STATE OF NEBRASKA
DEPARTMENT OF ROADS
ADDENDUM NO. 1
AND
ELECTRONIC BIDDING SYSTEM
AMENDMENT NO. 1
PROJECT NO. EACIM-80-4(123)
CONTROL NO. 61275
CALL ORDER F28
I-80 / US-83, NORTH PLATTE INTERCHANGE
LETTING DATE: APRIL 18, 2002

NEBRASKA DEPARTMENT OF ROADS	
TRAFFIC ENGINEERING DIVISION	
SIGN LOCATION PLAN	
PROJECT NAME	US-83, NORTH PLATTE INTERCHANGE
DATE	02/02
SCALE	AS SHOWN

PROJECT NO. EACIM-80-4 (123)	SHEET NO. 12
C.N. 8275

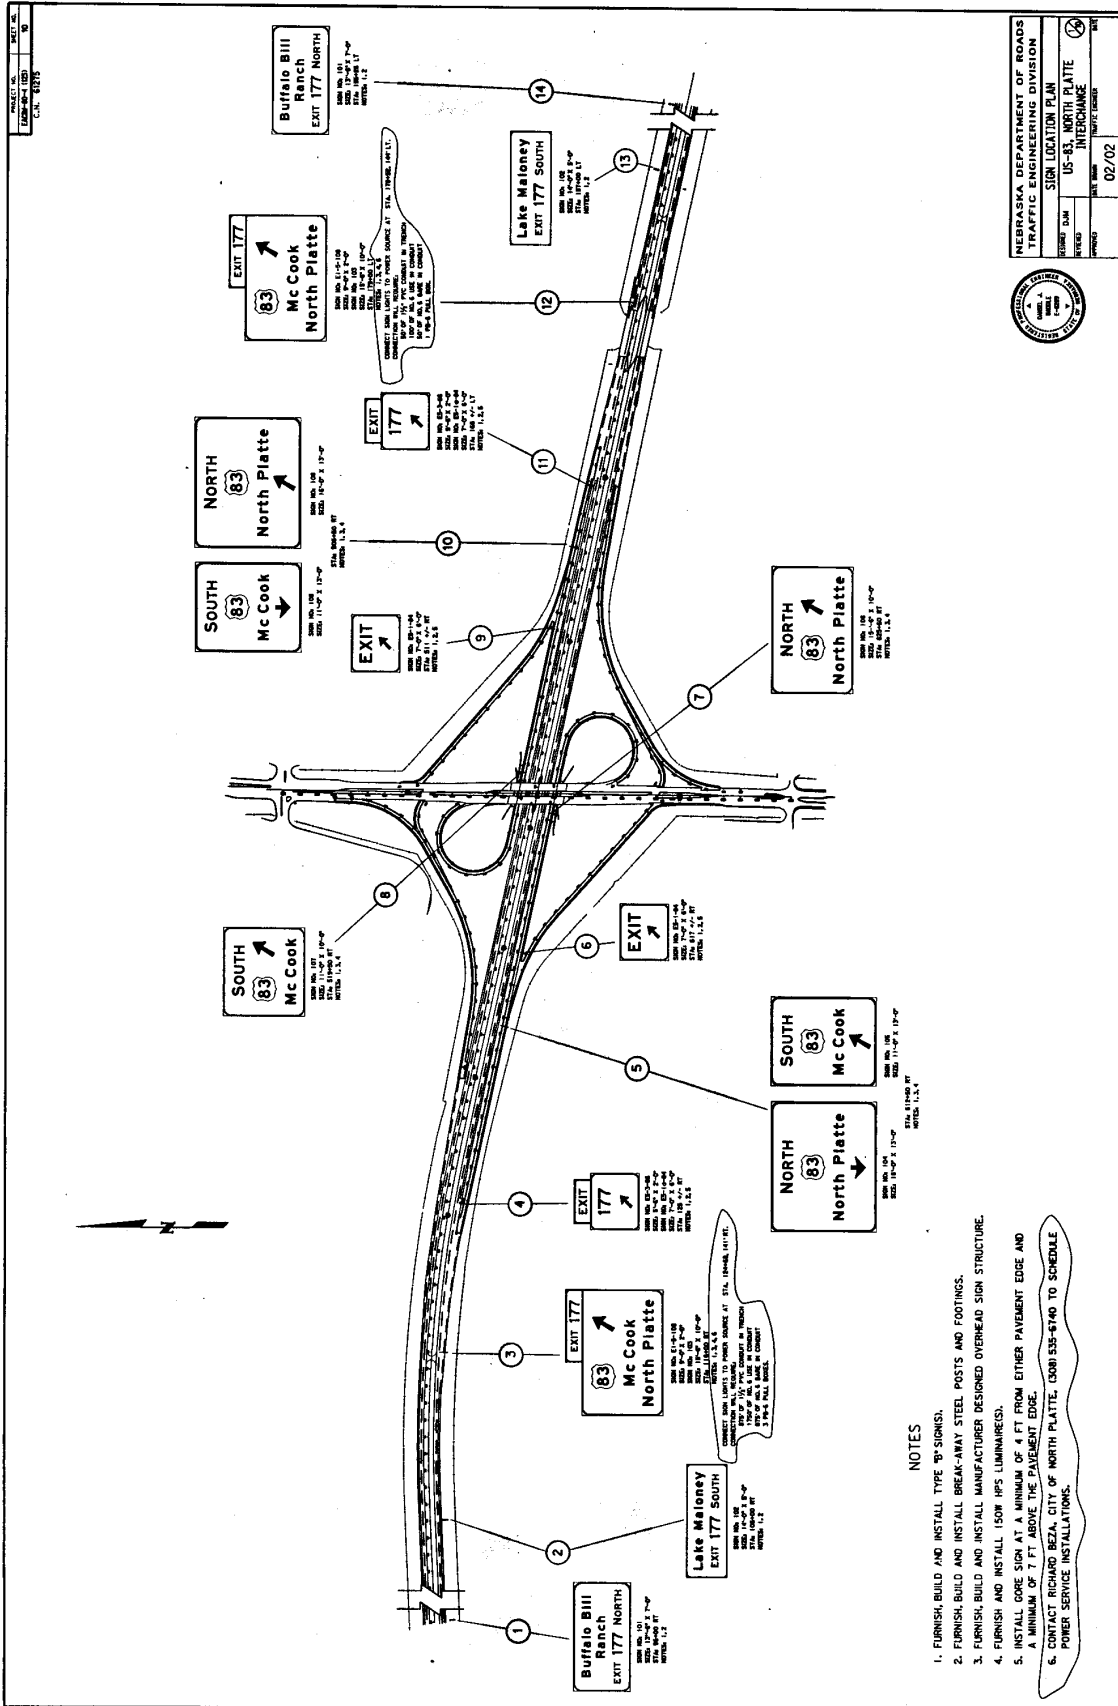
Plan sheets 10 and 12 will be revised as per the attached sheets. The changes on these plan sheets are circled.

TOWER FOUNDATION DETAIL
(WITH WINCH HOUSING)

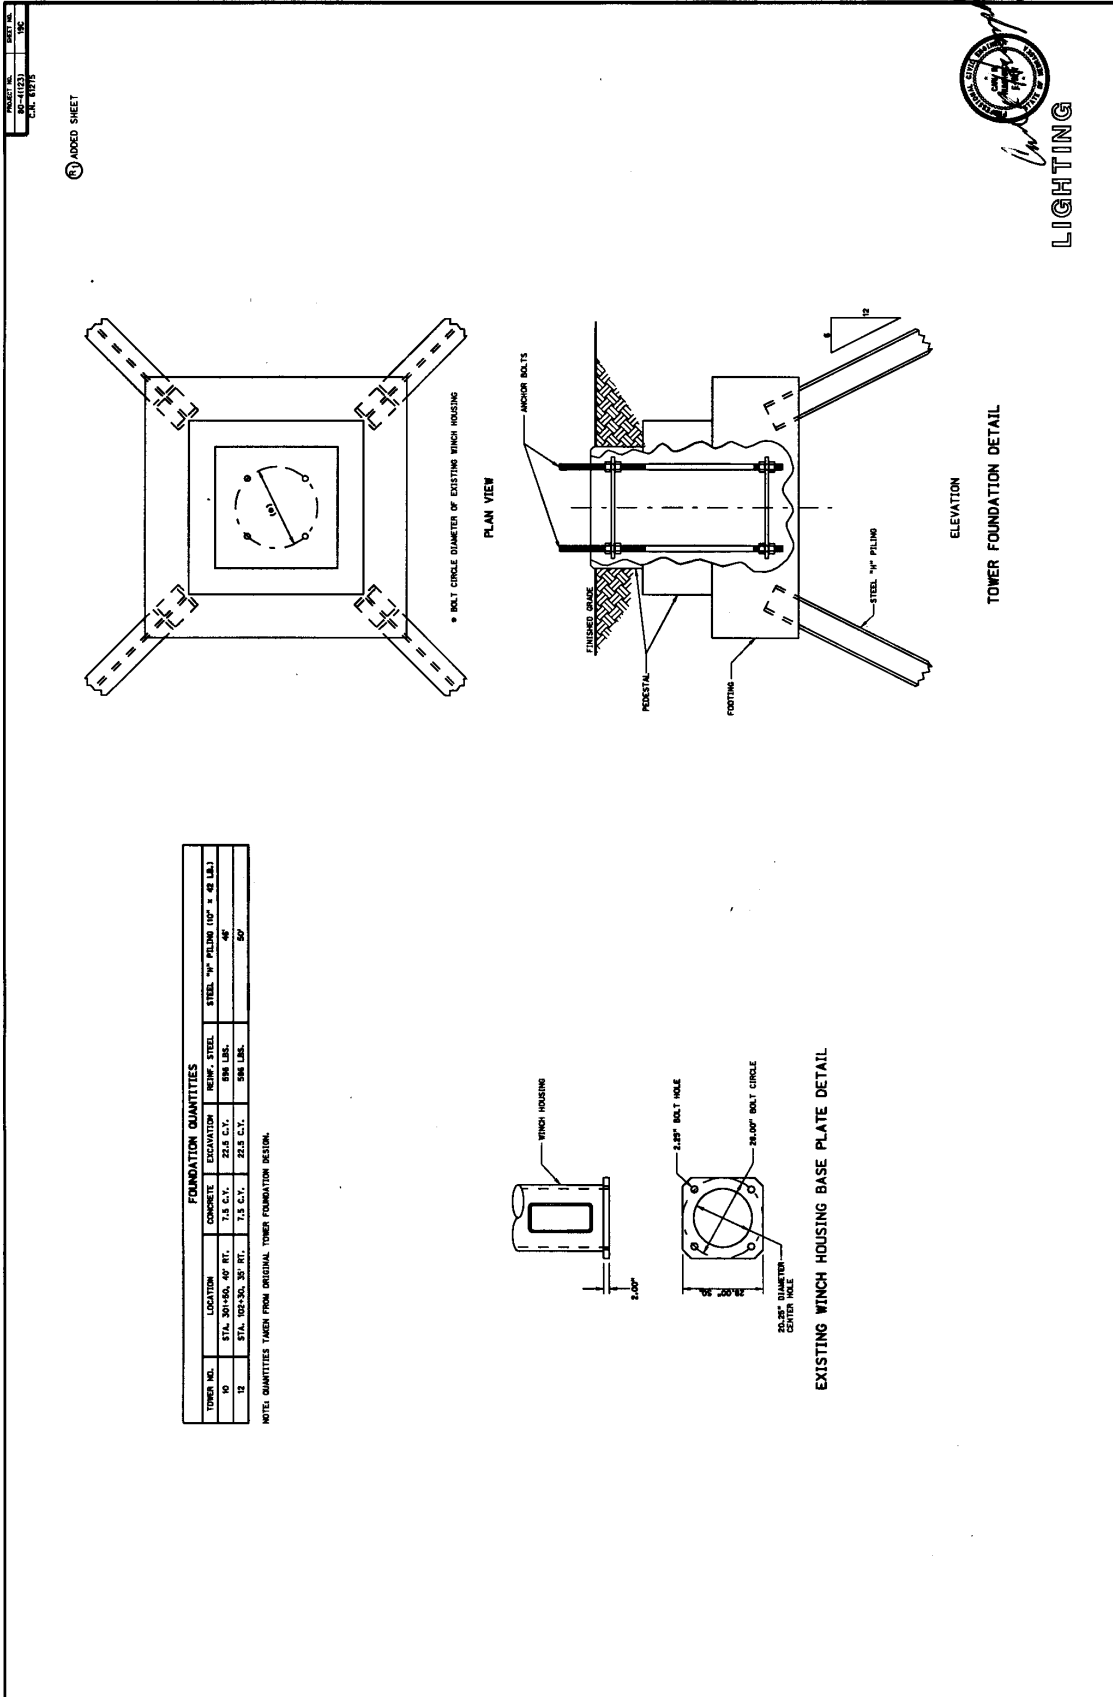
Plans sheets 19A, 19B, 19C and 19D will be added sheets to the plans. See the attached sheets for detail.

- NOTES:**
1. THE CONTRACTOR SHALL DESIGN A PILE FOUNDATION FOR EACH OF THE TWO TOWERS BEING RELOCATED. THE FOUNDATION SHALL BE DESIGNED TO SUPPORT THE FULL WEIGHT OF THE TOWER AND ALL EQUIPMENT. THE FOUNDATION SHALL BE CONCRETE. THE FOUNDATION SHALL BE 48" WIDE AND 48" DEEP. THE FOUNDATION SHALL BE 48" WIDE AND 48" DEEP. THE FOUNDATION SHALL BE 48" WIDE AND 48" DEEP.

2. FOUNDATION ANCHORAGE SHALL BE AS SHOWN IN THE TOWER FOUNDATION DETAIL AND AS DESCRIBED IN THE SPECIAL PROVISIONS. THE TOP 10 INCHES AND THE BOTTOM 6 INCHES OF EACH ANCHOR BOLT SHALL BE GALVANIZED. THE TOP 20 INCHES OF THE ANCHOR BOLT SHALL BE PAINTED WITH AN ANTI-RUST PAINT. THE ANCHOR BOLTS SHALL BE 1/2" DIA. GALVANIZED. THE ANCHOR BOLTS SHALL BE 1/2" DIA. GALVANIZED. THE ANCHOR BOLTS SHALL BE 1/2" DIA. GALVANIZED.

3. ANCHOR BOLTS MUST BE USED AS SHOWN AND THE GAGE IMPERECT BY THE ENGINEER BEFORE CONCRETE MAY BE POURED.
 4. ANCHOR BOLT GAGE MUST BE CENTERED IN THE CONCRETE FOOTING. A POWER TEMPLATE MUST BE INSTALLED AT BOTH THE TOP AND BOTTOM OF THE GAGE TO INSURE THAT THE ANCHOR BOLTS REMAIN PLUMB. LESS THAN 1/8" FROM VERTICAL. THE ANCHOR BOLTS SHALL BE INSTALLED IN THE CONCRETE FOOTING. THE ANCHOR BOLTS SHALL BE INSTALLED IN THE CONCRETE FOOTING. THE ANCHOR BOLTS SHALL BE INSTALLED IN THE CONCRETE FOOTING.

5. A DISTANCE NO GREATER THAN TWO ANCHOR BOLT DIAMETERS WILL BE ALLOWED BETWEEN THE TOP OF THE CONCRETE FOOTING AND THE BOTTOM OF THE WINCH HOUSING BASE PLATE.

6. A HARDENED STEEL FLAT WASHER WILL BE REQUIRED BETWEEN THE WINCH HOUSING BASE PLATE AND THE LEVELING NUT AND BETWEEN THE WINCH HOUSING BASE PLATE AND THE HOLD-DOWN NUT FOR EACH ANCHOR BOLT EMPLOYED.

7. ANCHOR BOLT NUTS SHALL BE CHECKED AND SYSTEMATICALLY TIGHTENED TO PROPER TENSION BY EITHER THE CONTRACTOR OR THE ENGINEER. THE CONTRACTOR SHALL BE RESPONSIBLE FOR THE PROPER TIGHTENING OF THE ANCHOR BOLT NUTS. THE CONTRACTOR SHALL BE RESPONSIBLE FOR THE PROPER TIGHTENING OF THE ANCHOR BOLT NUTS. THE CONTRACTOR SHALL BE RESPONSIBLE FOR THE PROPER TIGHTENING OF THE ANCHOR BOLT NUTS.

8. FILL THE CAVITY BETWEEN THE TOP OF THE CONCRETE FOOTING AND THE TOP OF THE WINCH HOUSING BASE PLATE WITH GROUT IN ACCORDANCE WITH THE SPECIAL PROVISION TITLED "DIRECTIONS FOR GROUTING HIGH MAST TOWERS" WHICH IS INCLUDED AS A PART OF THIS CONTRACT.

9. PROVIDE A CAPPED 1-1/2" DIAMETER SPARE CONDUIT ROAD IN ALL TOWER FOUNDATIONS.
 10. THE ENGINEER OR HIS REPRESENTATIVE MUST BE PRESENT AT ALL TIMES DURING TOWER INSTALLATION AND INSPECTION. THE CONTRACTOR SHALL BE RESPONSIBLE FOR THE PROPER INSTALLATION OF THE TOWERS. THE CONTRACTOR SHALL BE RESPONSIBLE FOR THE PROPER INSTALLATION OF THE TOWERS.
